62 WOLSELEY ROAD, LONDON, N8 8RP: ECO HOUSE SCHEME

NON-MATERIAL AMENDMENT APPLICATION

PLANNING STATEMENT
MARCH 2023

16. Revised rear elevation (Drawing number 591-122-P3). External wall facing rear gardens of Glasslyn Road. Changes to the ground floor windows will not be visible to the properties at Glasslyn Road.

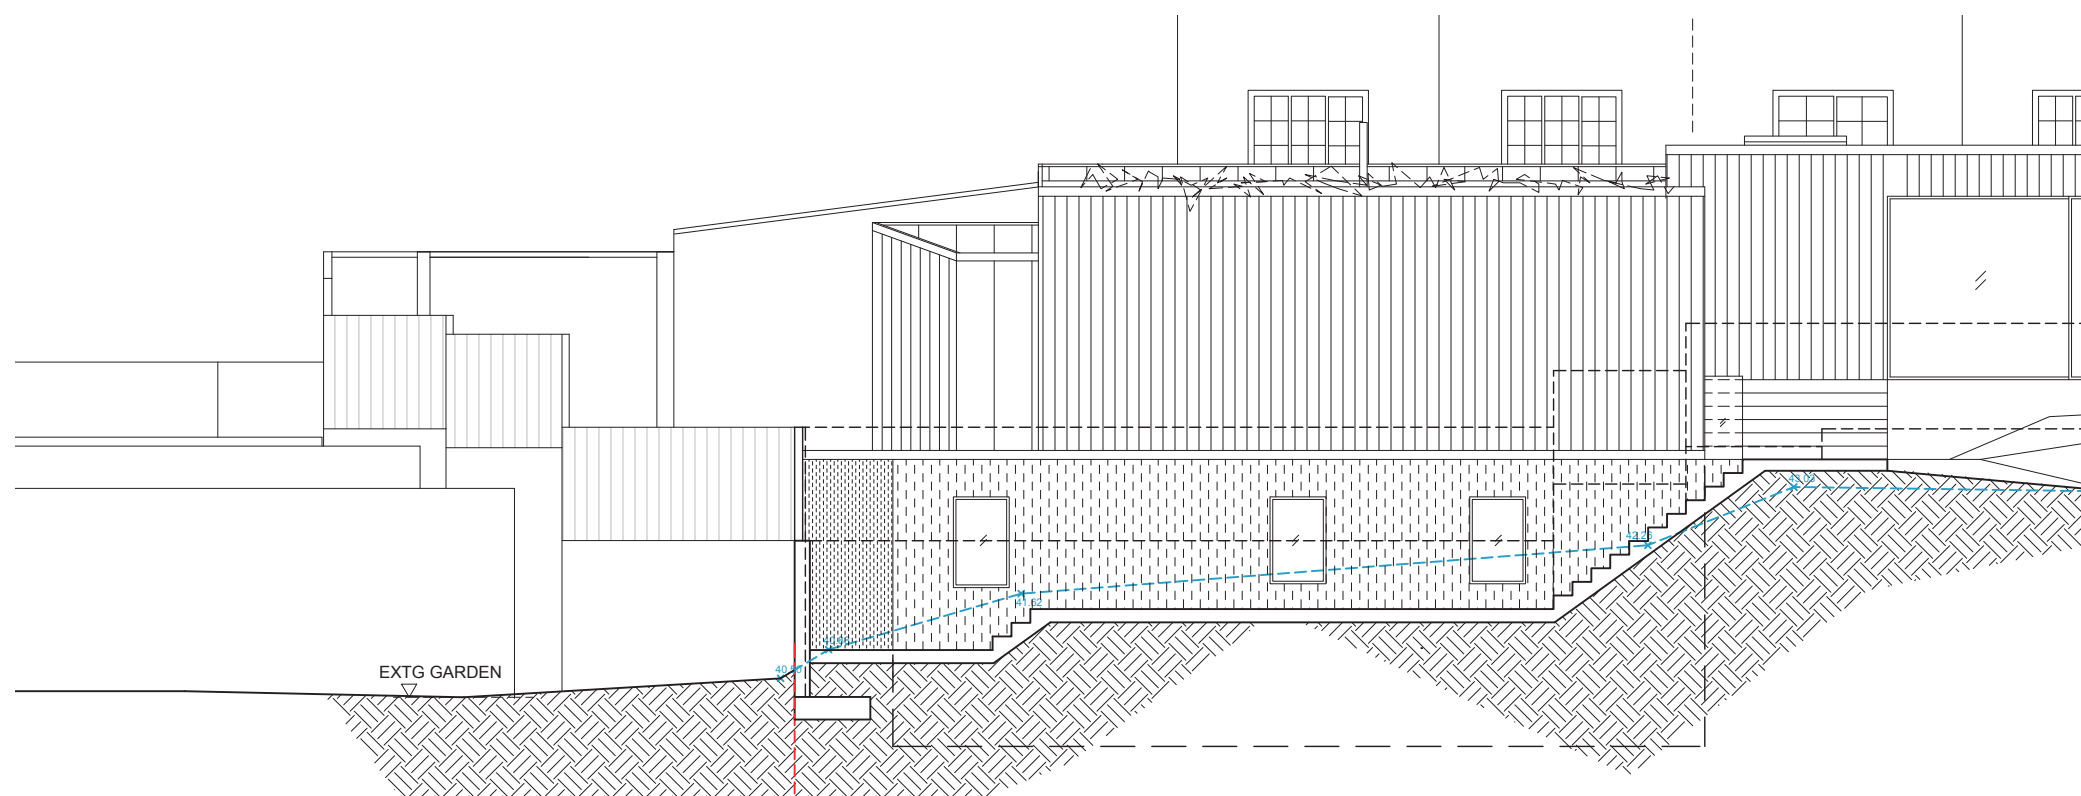
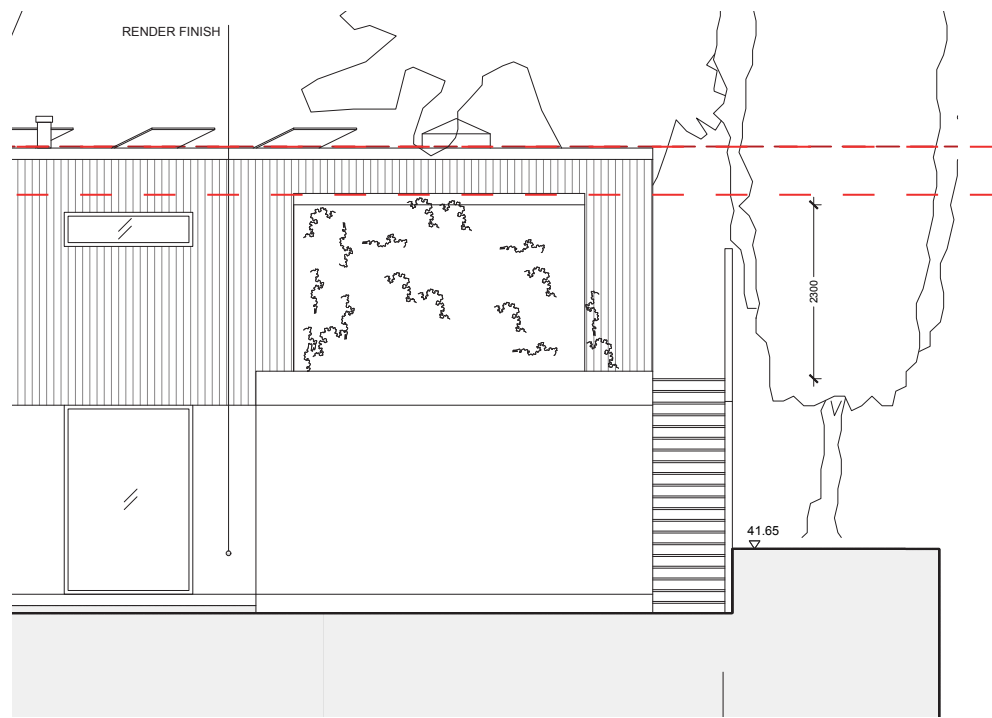
5.1. Lower Level Fenestration: There have been minor changes to windows on the lower level as a result of changes in the plan of the lower level, but the 3no. windows concerned are located below the fence line so that there is no possible overlooking of adjoining properties, and the changes are therefore non-material.

18b. 3D studies of the revised upper floor Kitchen projecting annexe. North-East Elevation (Side elevation)

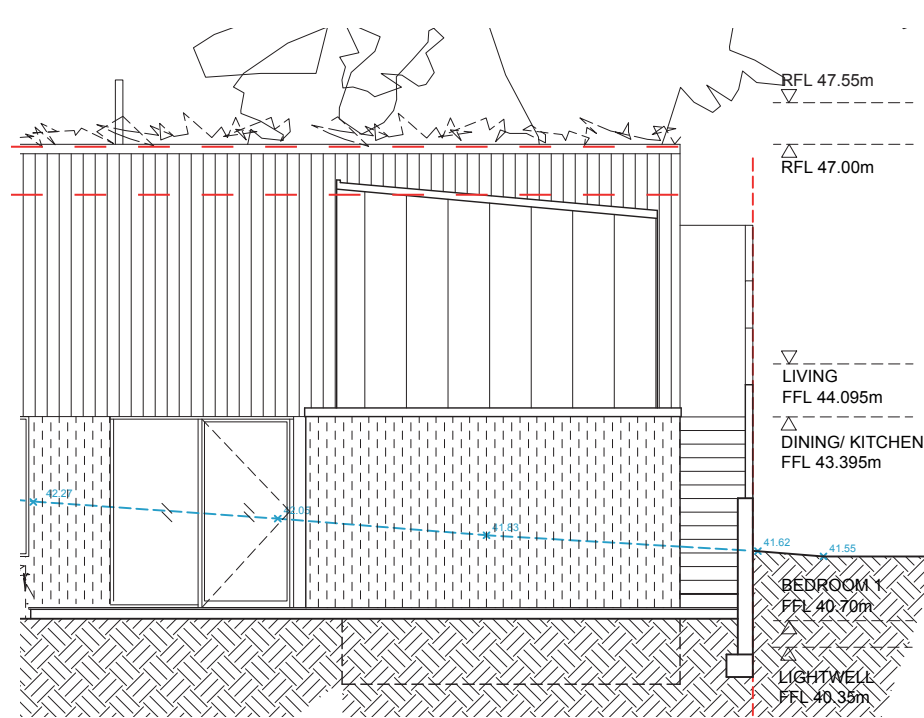
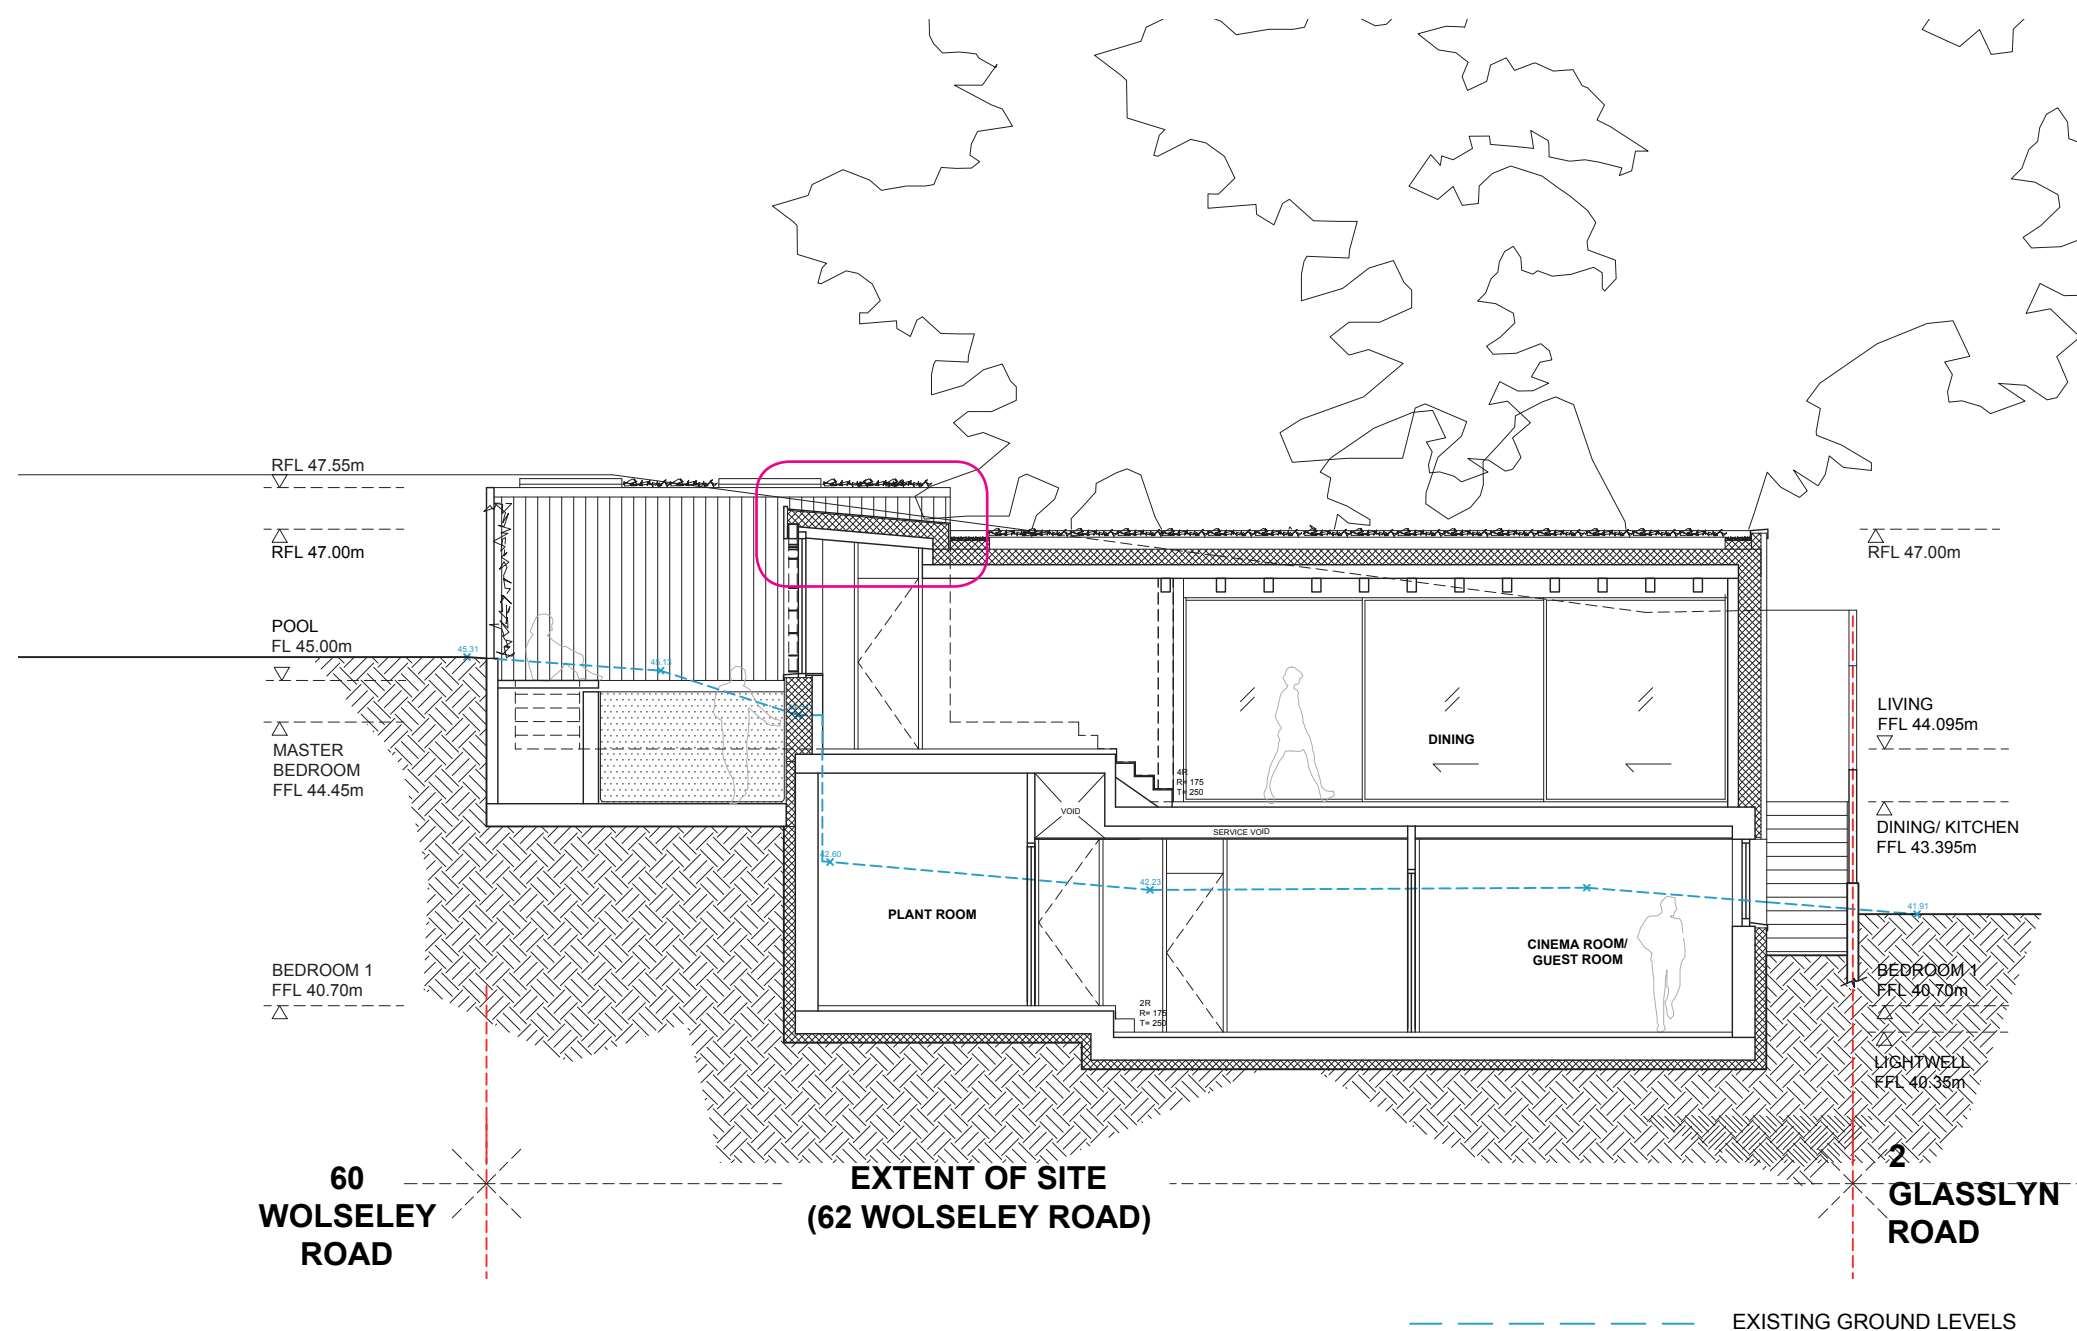
- 6.1. Projecting Annexe: The roof profile of the zinc-covered extension to the upper floor kitchen has been altered to form a slope to the rear, in order to improve drainage and to increase the height of the south-facing window, which is intended to maximise passive solar gain.
- 6.2. Height of Annexe: The height of the annexe in the revised design is predominately lower than the height of the annexe of the approved scheme.

19. Section through proposed pool and main building showing sloped roof with large fixed light to allow natural light to penetrate deep into the internal spaces. (Drawing number 591-113-P3 Proposed section X-X).

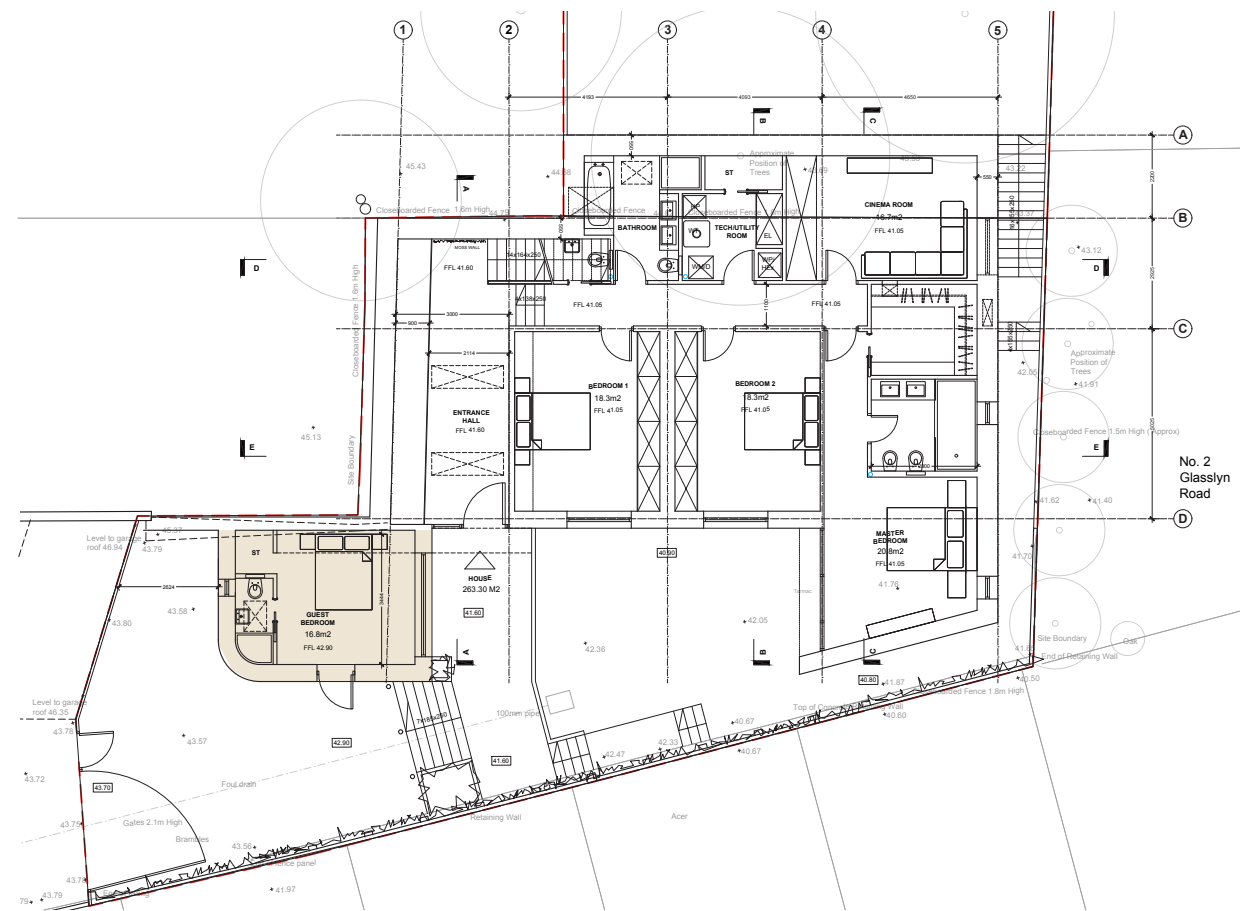
- 6.3. Main Roof Profile: At the southern end of the main roof a sloping section of roof has been introduced, which is zinc-covered in order to relate in material and in form to the roof of the projecting annexe.
- 6.4. Rainwater Harvesting: This zinc-covered, i.e. 'non-green', section of the main roof allows an increased amount 'clear water' to be harvested and stored for use in WC flushing etc.
- 6.5. Solar Gain: In a similar manner to the projecting annexe, the pitched roof element increases the height of the south-facing window of the living room to maximise passive solar gain. Although the roof pitch raises the ridge by approximately 300mm, the ridge line remains below the 2m height of the boundary fence to no.60 Wolseley Road.

21. Revised lower ground floor plan (Drawing number: 591-110-P2)

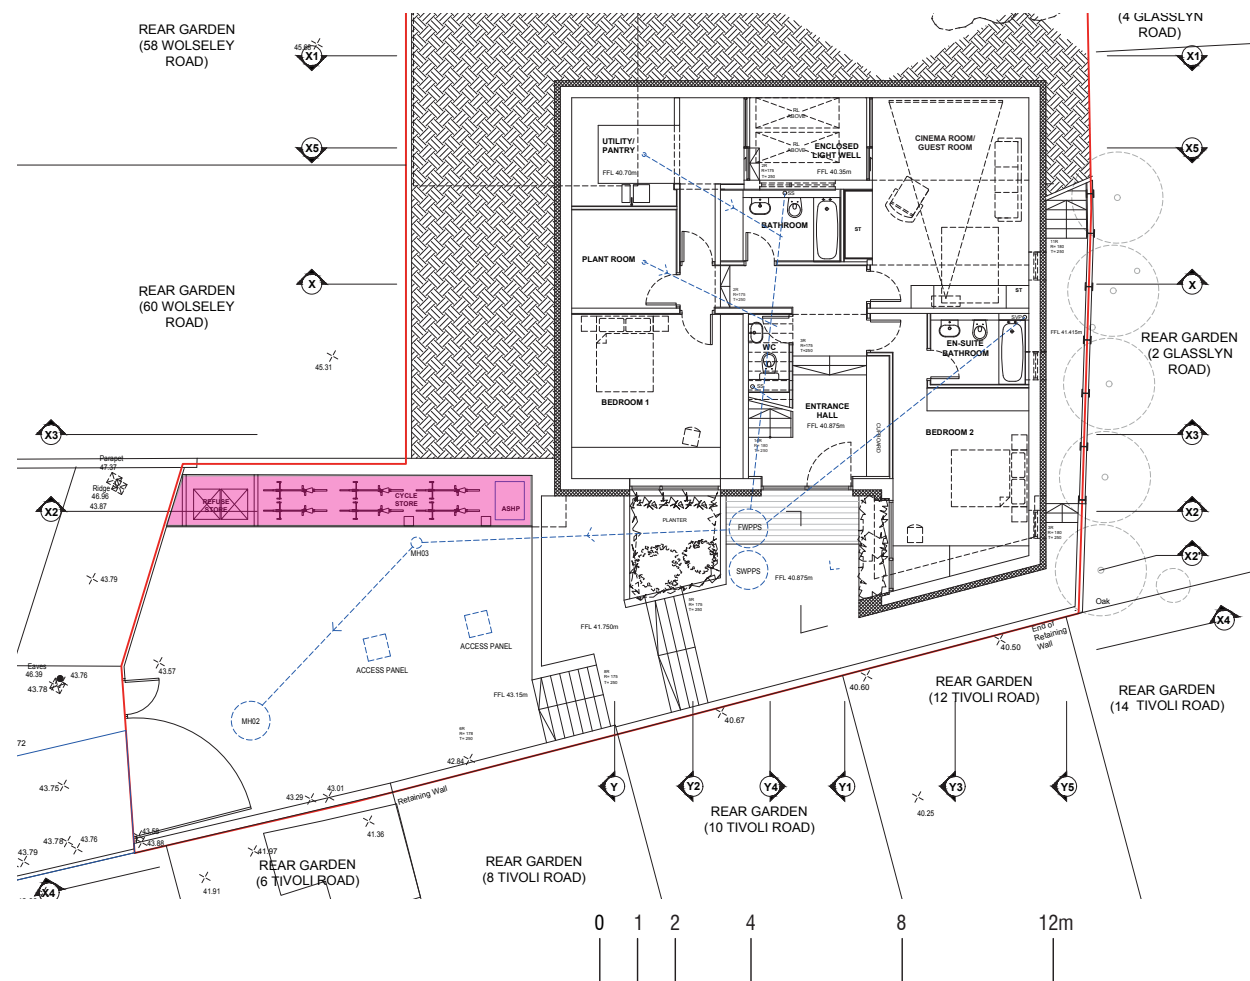
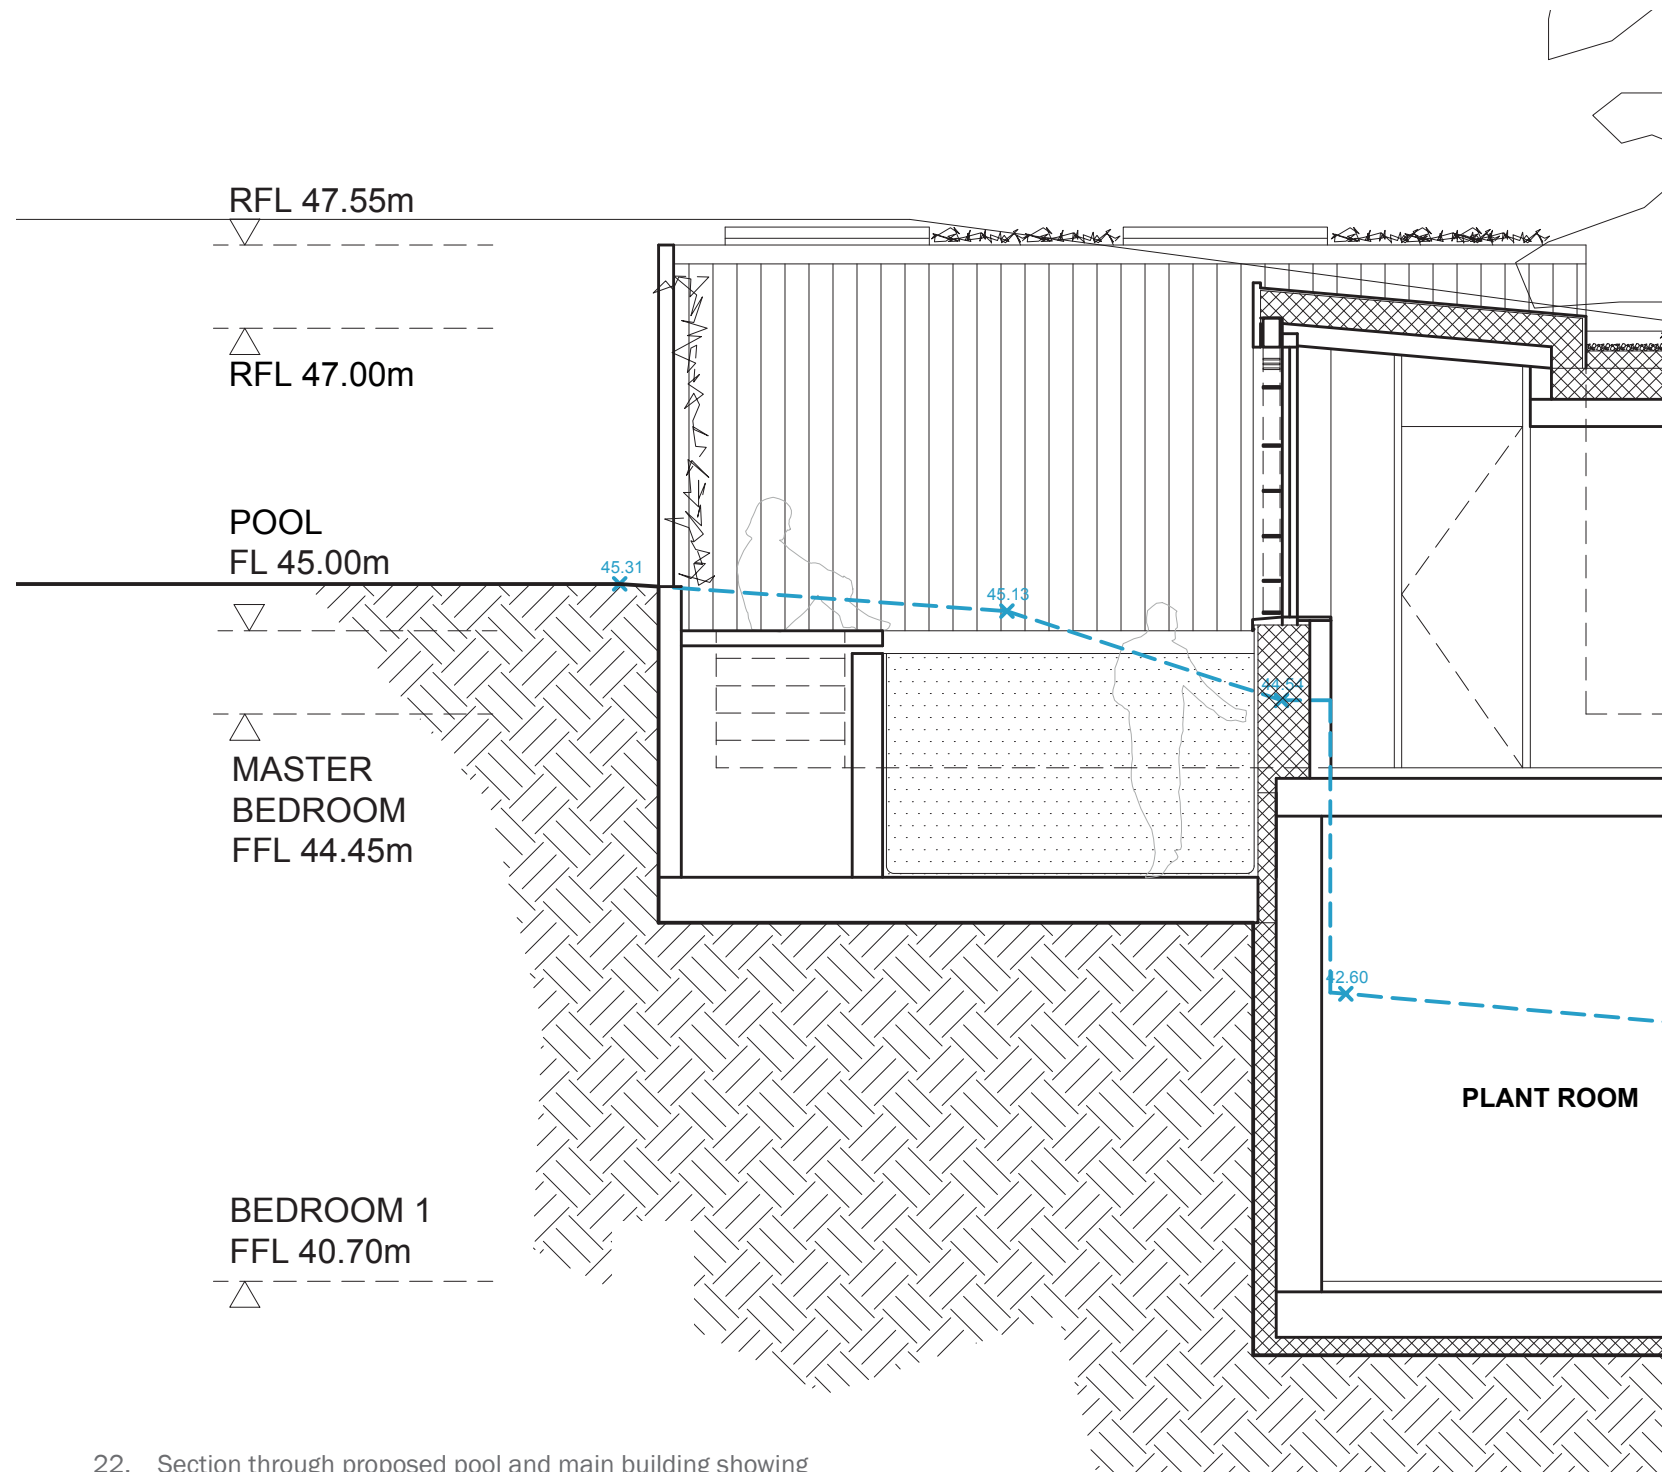
Refuse/ recycling store and cycle store added

- 7.1. Entrance Courtyard Reconfigured: Following the removal of the Office/Guest block from the Entrance Courtyard, space is available for a refuse and recycling store, appropriately located close to the house entrance, as well as space to accommodate a cycle store and an air-source heat pump, while sufficient space has been maintained for a car to manoeuvre and park.
- 7.2. Cycle Store: The cycle store, which is to be covered and secure, is located on the upper level of the Entrance Courtyard to avoid the necessity to take cycles up or down stairs.
- 7.3. Air-Source Heat Pump (ASHP): The location of the housing to accommodate the air-source heat pump, whilst being close to the lower ground floor plant room, is sufficiently distant from neighbouring properties to prevent any noise disturbance.
